Section 16 Planning Application for Proposed Minor Relaxation of the Maximum Domestic GFA for the Permitted Residential Development of the Urban Renewal Authority Sai Yee Street/ Flower Market Road Development Scheme ("YTM-013")

**Planning Application No. A/K3/603
-Submission of Response-to-Departmental Comments-**

Responses to Departmental Comments Table

Drawing Title							
MAJOR PEDESTRIAN ROUTE TO / FROM PRINCE EDWARD MTR STATION							
Designed	CHM	Checked	HWL	Scale	NTS	Date	MAY 2024

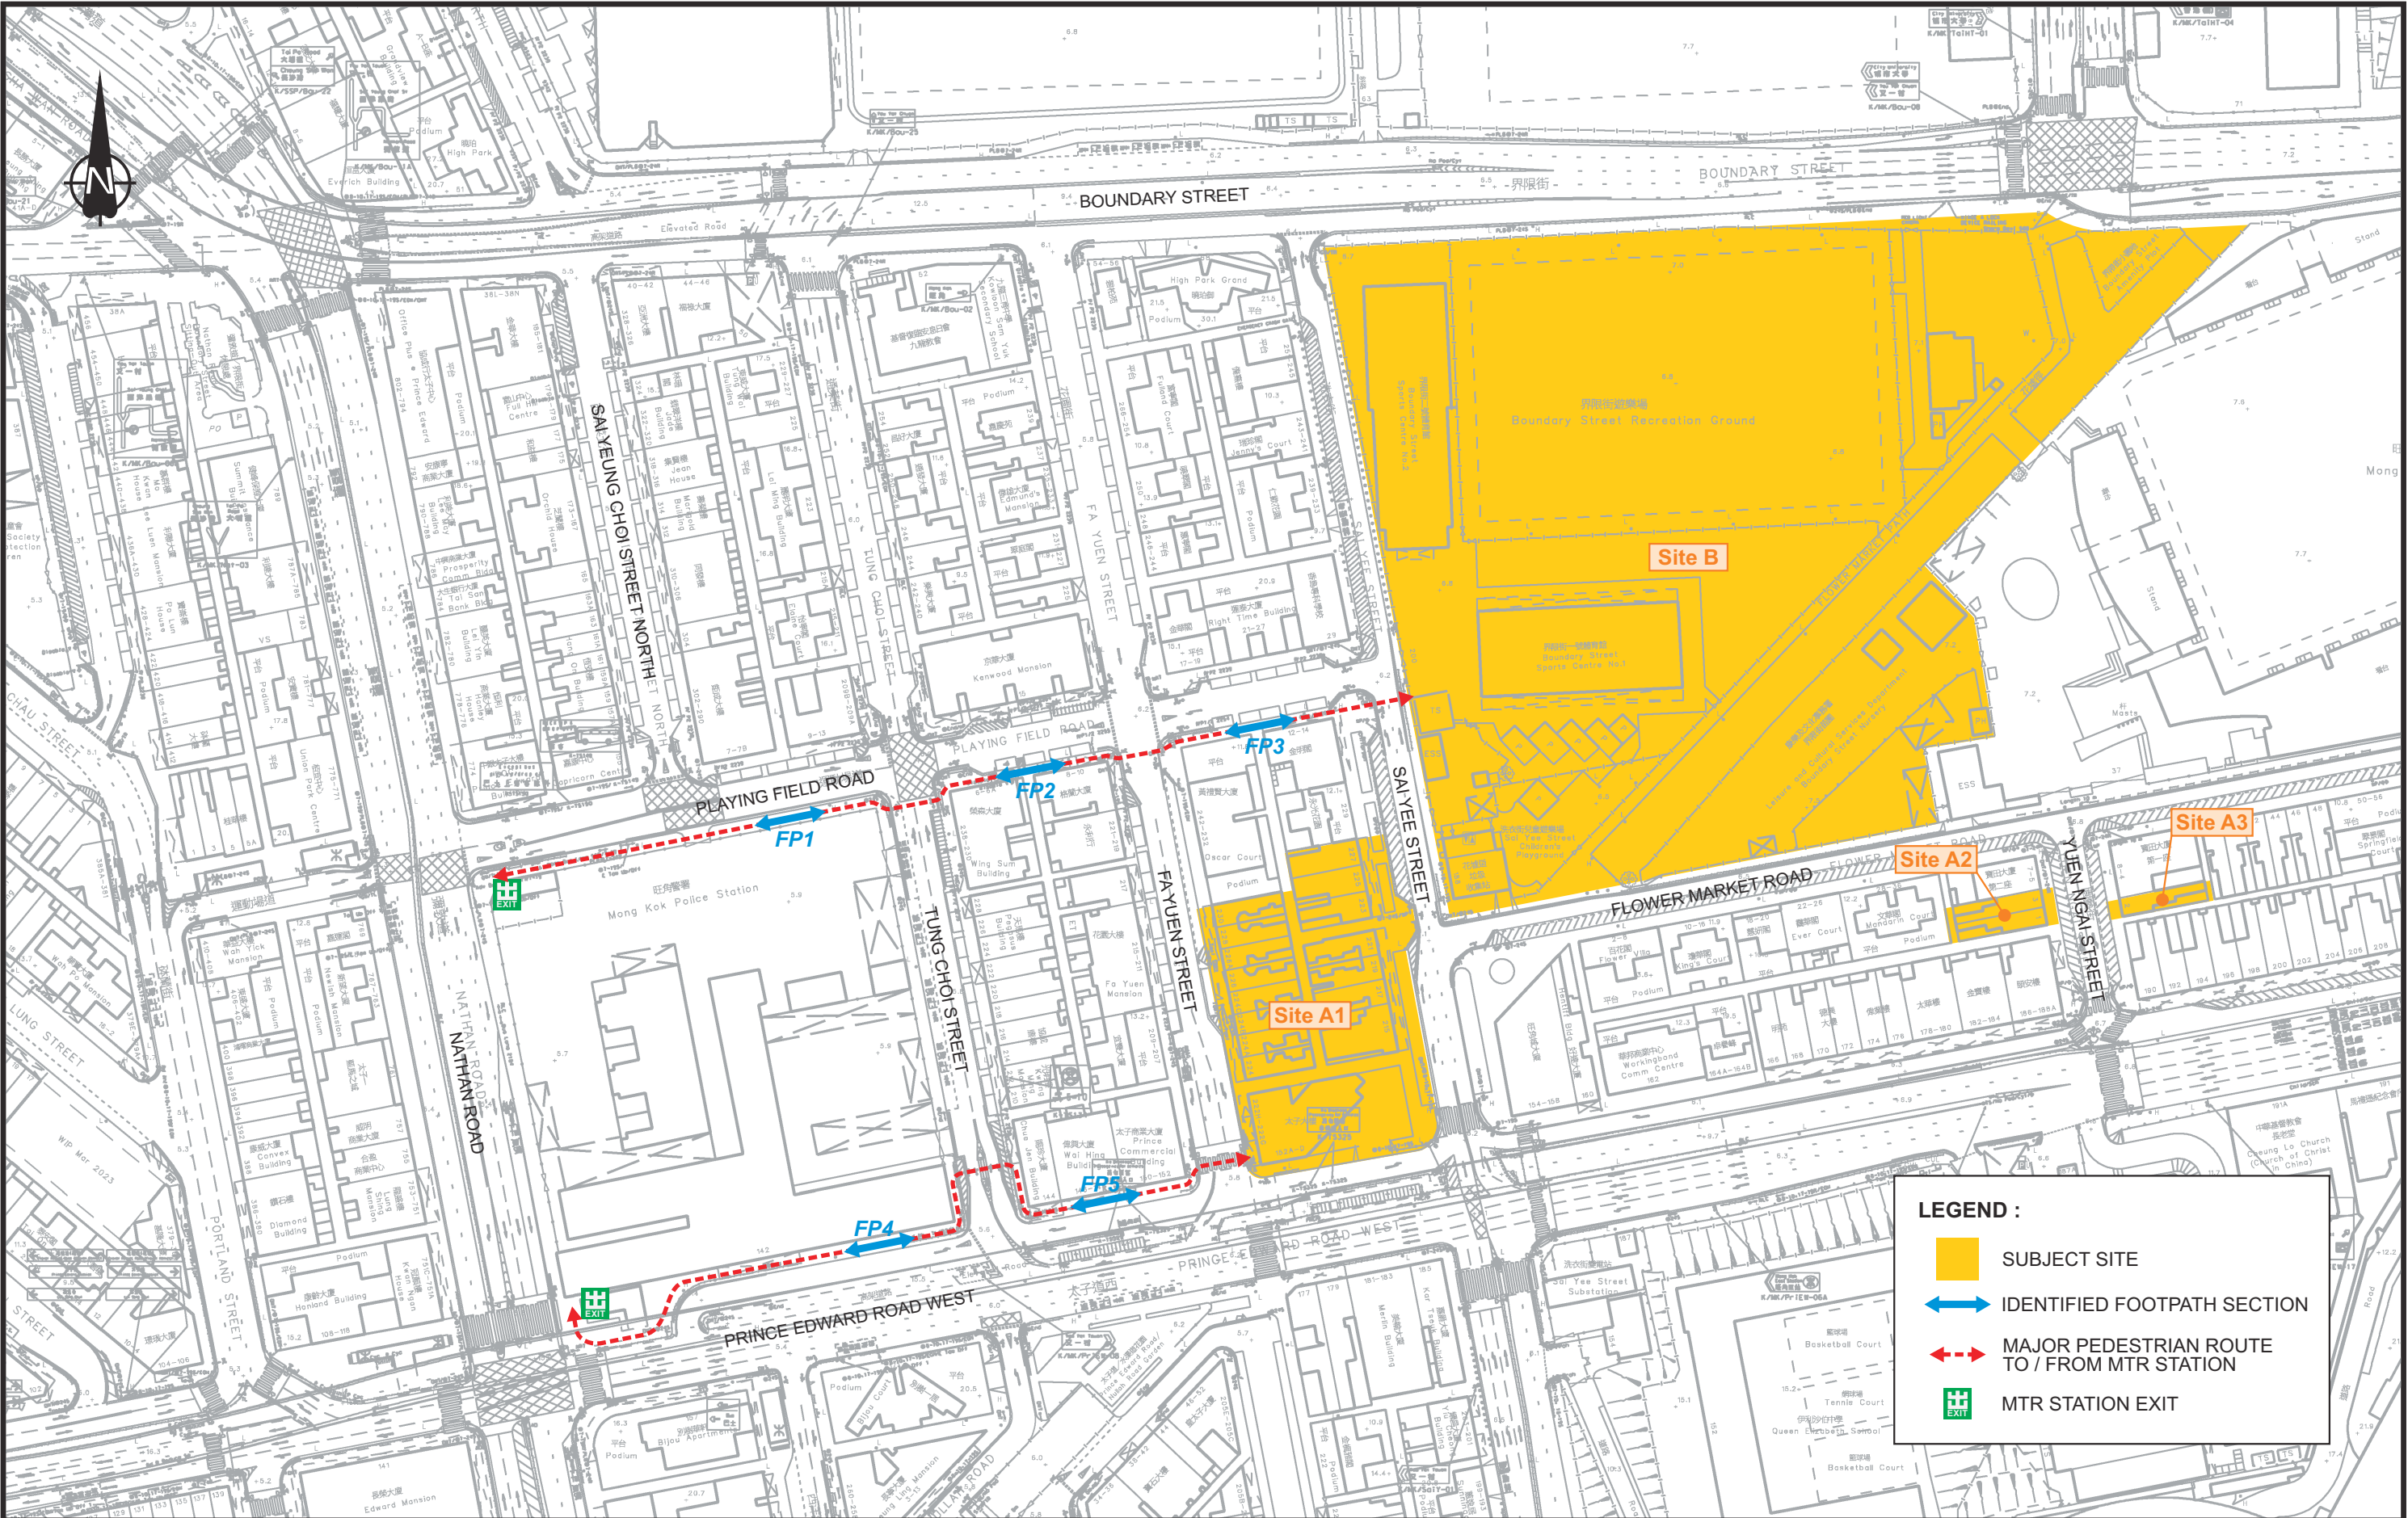
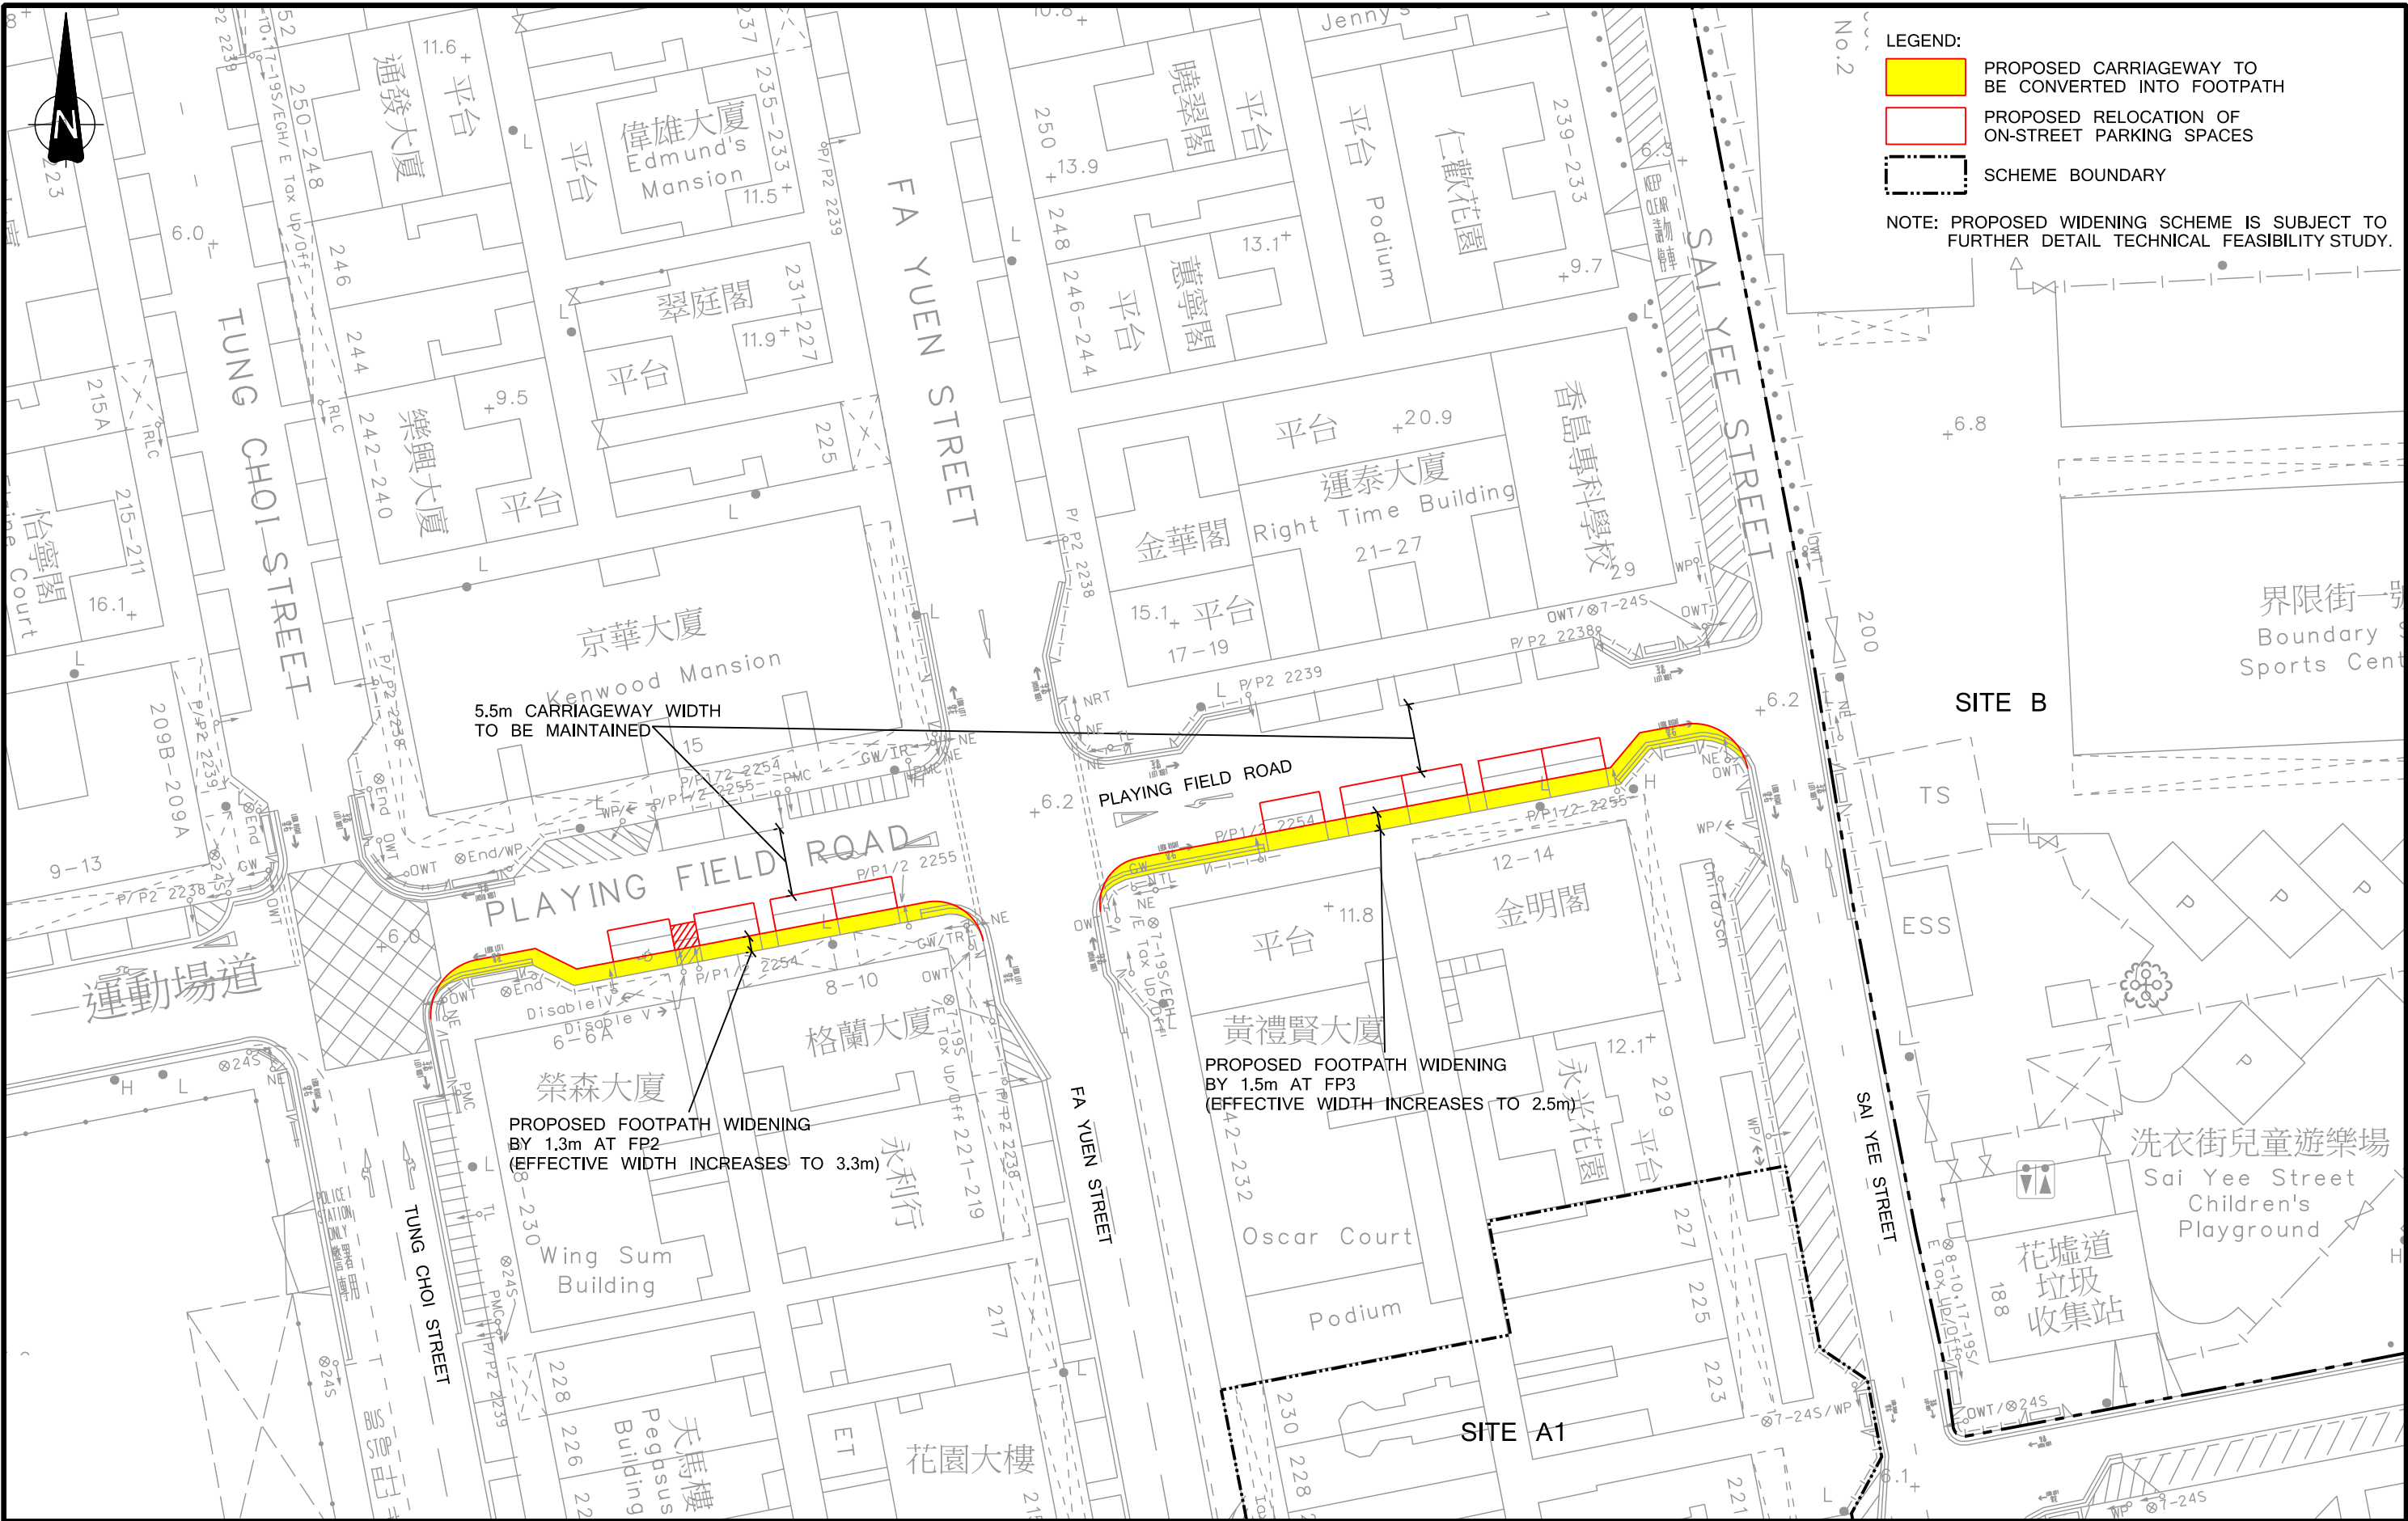
Departmental Comments	Responses																																																																								
	widening is also proposed widening along part of Playing Field Road which was identified as another major pedestrian route to Prince Edward MTR Station. The Supplementary LOS Assessment is appended to this TIA for reference and is separate from this S16 Planning Application. Section 5.2.8 of the TIA report (See Appendix 3) is supplemented accordingly. The final design and implementation of the proposed pedestrian improvement measures will be determined at detailed design stage and are subject to agreement with TD and other relevant Government departments.																																																																								
(g) Please note the updated information on public transport services as follows: Franchised Bus

- 2.1.3 It is proposed to widen the footpath at FP2 and FP3 by reducing the carriageway width into 5.5m as shown in **Drawing No. APP2**. The road width for one-way carriageway is made reference to Transport Planning and Design Manual Volume 2 Chapter 3.4, such that carriageway width of one-way traffic at service roads for all vehicles is 5.5m which is sufficient for normal operation. The proposed scheme details at FP2 and FP3 are summarized in **Table APP-7**.
